**AMENDMENTS TO THE DRAWINGS**

**REMARKS**

FIG.5C

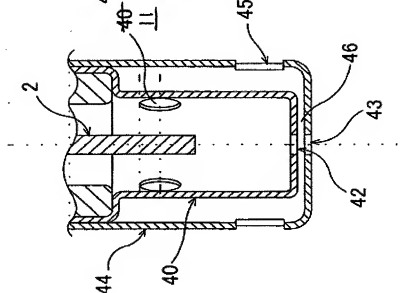
In response to the drawing objections, reference numeral “40” at the right-hand side of Fig. 5(C) has been changed to “11” to designate inner-wall gas inlet openings. Reference numeral “26” has been removed from Fig. 6.
